SUBJECT: AMENDMENT NOS. 47 AND 12 TO FACILITY OPERATING LICENSE NOS.
NPF-14 and NPF-22 SUSQUEHANNA STEAM ELECTRIC STATION, UNITS 1 AND 2

PENNSYLVANIA POWER & LIGHT COMPANY
ALLEGHENY ELECTRIC COOPERATIVE, INC.
DOCKET NO. 50-387
SUSQUEHANNA STEAM ELECTRIC STATION, UNIT 1
AMENDMENT TO FACILITY OPERATING LICENSE

ATTACHMENT TO LICENSE AMENDMENT NO. 47
FACILITY OPERATING LICENSE NO. NPF-14
DOCKET NO. 50-387

SAFETY EVALUATION

FIGURE 6.2.2-1
UNIT ORGANIZATION

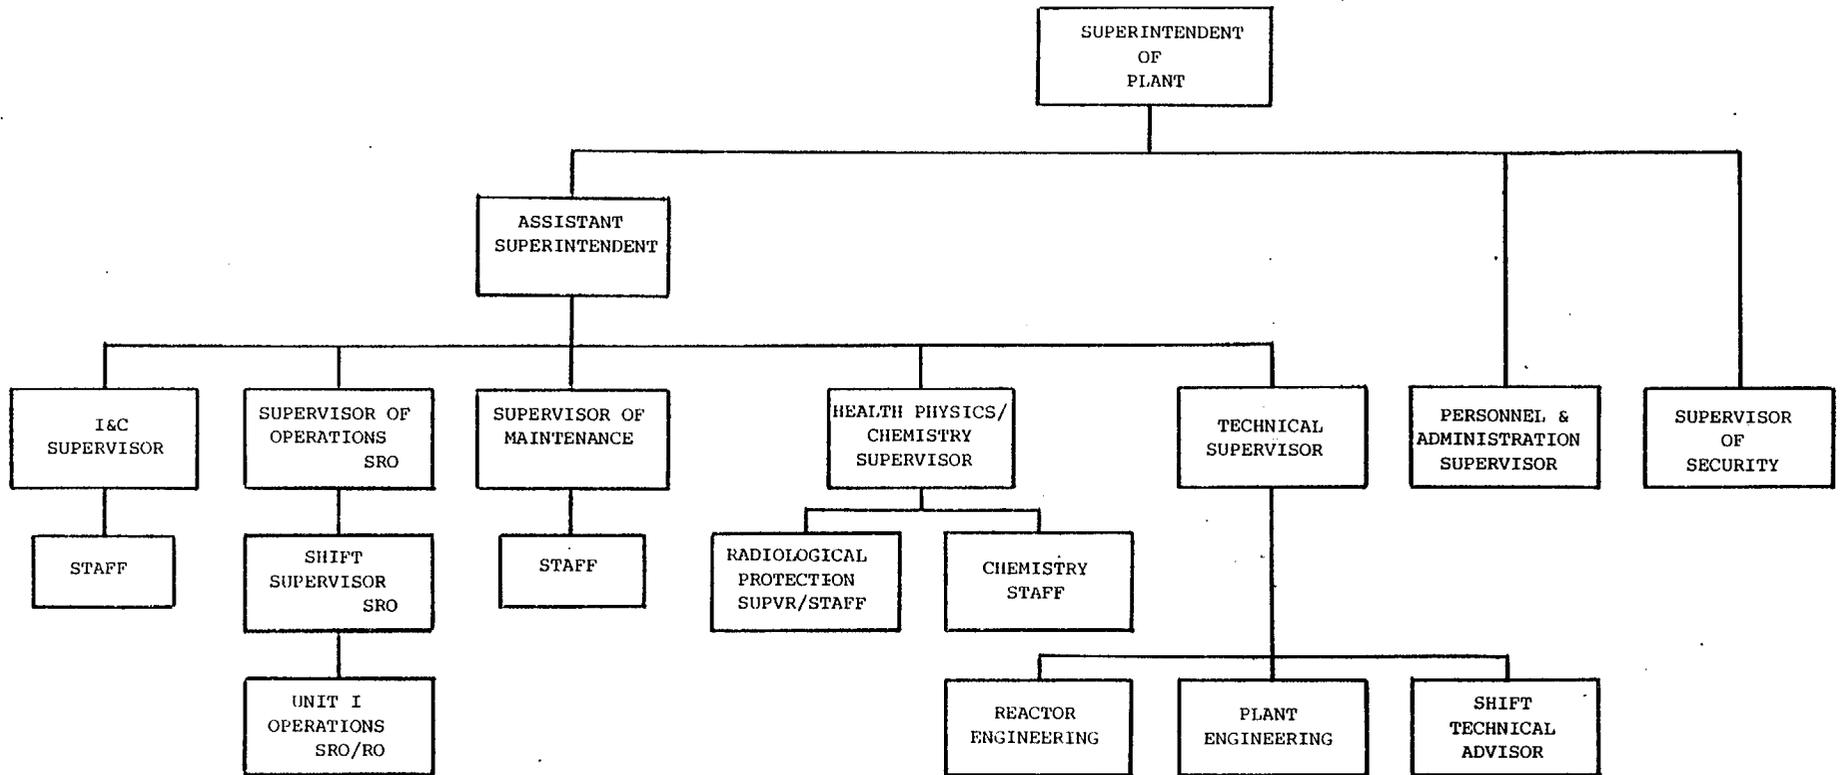
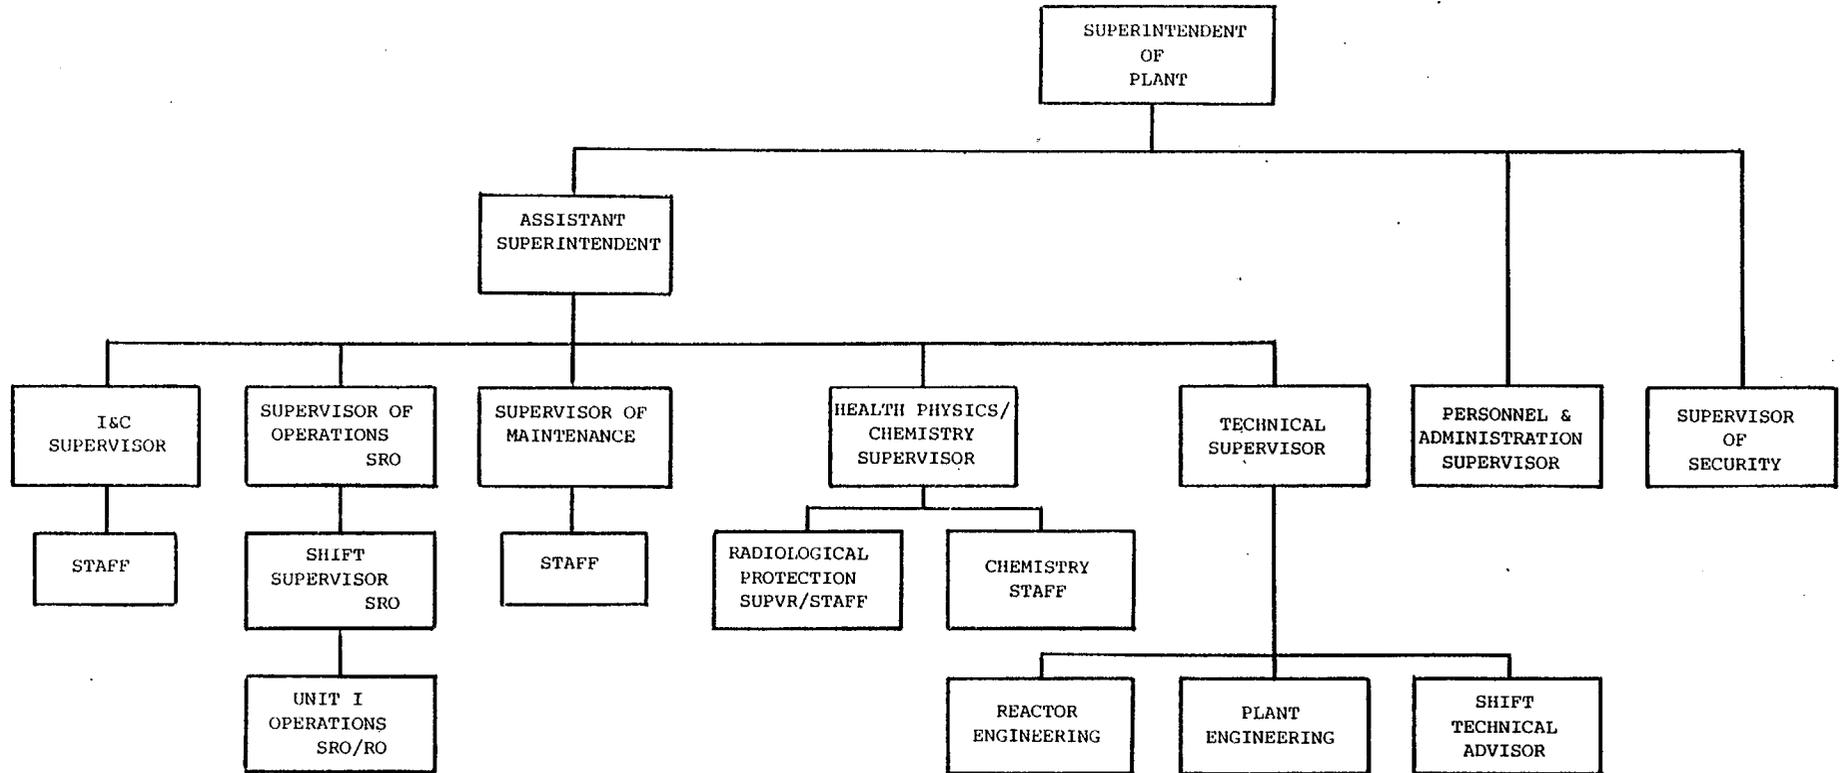
1. Figure 6.2.2-1 - the licensee has established two new positions at SSES. These are the Health Physics/Chemistry Supervisor and the Radiological Protection Supervisor. The radiological protection staff that formerly reported to the Health Physics Supervisor now reports to the Radiological Protection Supervisor who reports to the new Health Physics/Chemistry Supervisor. The chemistry staff that formerly reported to the Technical Supervisor now reports to the new Health Physics/Chemistry Supervisor.

The NRC staff finds this change acceptable as it does not delete any function needed to support the operation of the SSES and it meets the staff position on plant staffing described in Regulatory Guide 1.33, Quality Assurance Program Requirements (Operations).
